INTERNATIONAL BUILDING CODE – FIRE SAFETY

FS2-09/10 701.2 (New)

Proposed Change as Submitted

EXAMPLE 1
BUILDINGS ON THE SAME LOT
CURRENT LANGUAGE

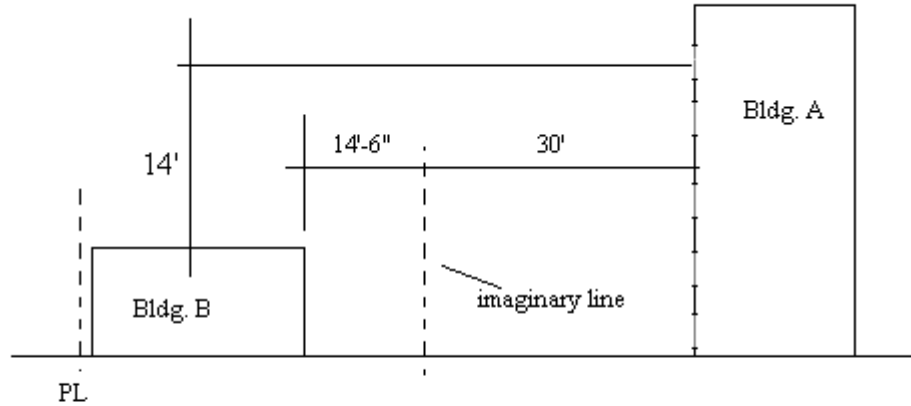
Current code language has only one measurement, that of the separation distance to the adjacent building. So since the measurement to Bldg. B (adjacent building) is less than 15 feet, then the code provisions apply regardless of how far Bldg. A is from the imaginary line.

Bldg. A is non-sprinklered and needs 30 feet of separation to keep glazing. Building B has site constraints because of a property line.

EXAMPLE 2
BUILDINGS ON THE SAME LOT
PROPOSED LANGUAGE
30 FEET OR MORE OF SEPARATION

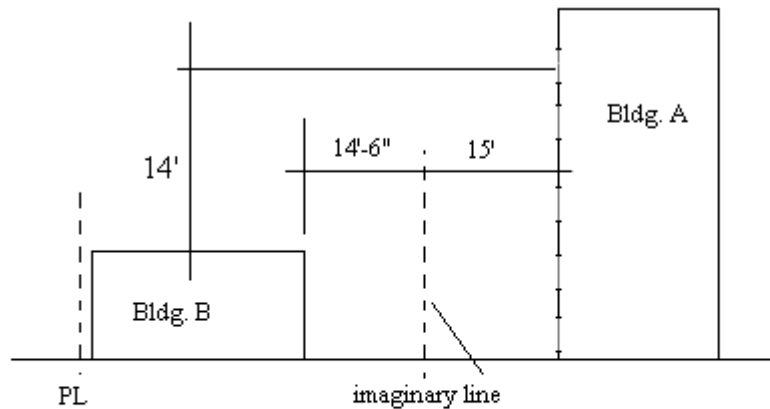
Proposed code language would have no requirements for protection of either the glazing or the roof under Section 705.8.6. This is because the aggregate fire separation distance of the two buildings is not less than 30 feet.

EXAMPLE 3
BUILDINGS ON THE SAME LOT
PROPOSED LANGUAGE
LESS THAN 30 FEET OF SEPARATION

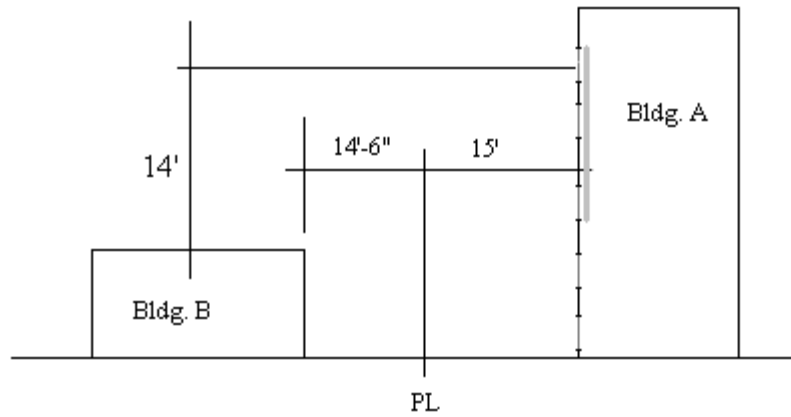
With the proposed new language, either the openings in Bldg. A or the roof of Bldg. B would be required to be protected since the aggregate of the two separation distances is less than 30 feet. Again, this is consistent with what we believe this section intended.

Proposed new Building A - less than 30 feet of separation

Bldg. A is a new building being proposed. The openings within the 15 foot vertical measurement would be required to be protected. This is due to the aggregate fire separation distance of less than 30 feet.

Existing Bldg. B would not be required to be protected.

EXAMPLE 4
BUILDINGS ON SEPARATE LOTS
BUILDING A IS PROPOSED

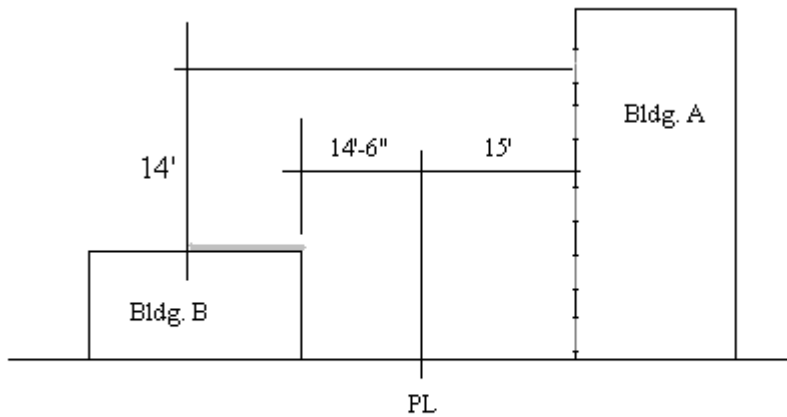
Proposed new Building B - less than 30 feet of separation

Building B is a new building being proposed. The roof and supporting elements would be required to be protected. Building A would not require any modifications to it.

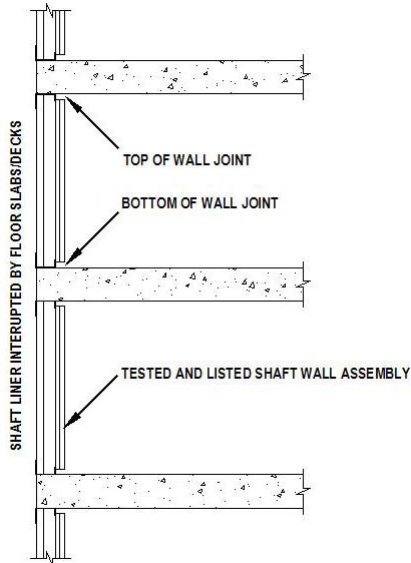
Substantiation: A shaft is intended to be a continuous assembly (fire barrier) from its lowest point to its highest point, with all openings, joints and penetrations suitably protected or sealed. This revision serves simply to clarify the intent of how this protection will be maintained.

When a shaft is hung entirely from the floors it traverses and is constructed of wall materials (e.g. gypsum boards, concrete masonry units) that are joined one to another from top to bottom, there would normally not be any intermediate floor slabs that would bisect the shaft wall, and therefore no fire resistive joint systems within the wall.

On the other hand, when a shaft enclosure is constructed of independent wall segments that rest on top of each floor slab/deck that the shaft traverses, there will be a joint between the wall segments and the floor slab/deck above, as well as between the wall and the floor slab/deck below it. Clearly both types of joints will occur at each level this shaft wall assembly is intended to protect. Shaft construction is unique in that the joint at the top of the wall and at the bottom of wall are equally important in maintaining the anticipated protection.

1 HR FIRERESISTANCE RATED WALL ASSEMBLY:
 2"x4" WOOD STUD
 5/8" TYPE X GYPSUM WALLBOARD

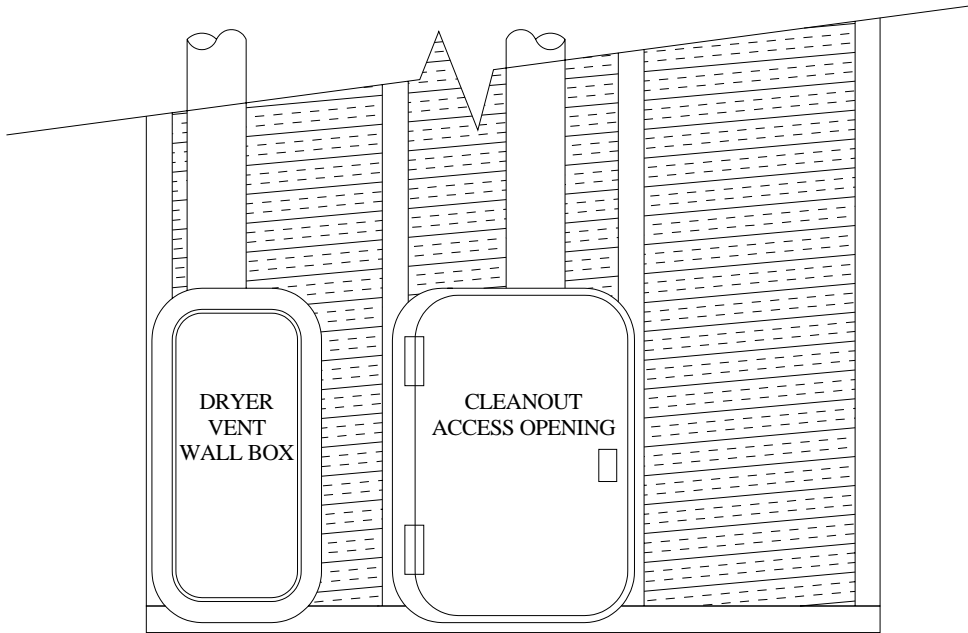
Either a "T" rating is appropriate or it is not. I have included a drawing of the absurdity of the current code requirement. If a dryer vent box is located in a 1 hour wall, the box penetration must have an F and T rating. Right alongside the dryer vent box, a cleanout wall opening to a cast iron pipe is shown. That opening only requires an F rating. Yet, the hazard is the same for both openings. Anything you say about the one opening, you can say about the other opening. This is true for so many other wall penetrations that are not boxes.

So, the real question is, do we need a T rating (in addition to an F rating) for wall penetrations? I do not believe we do. That is why I would encourage the membership to vote to approve Code Change F71-09/10. If the membership believes a T rating is necessary, then I have provided that opportunity with Code Change F70-09/10.
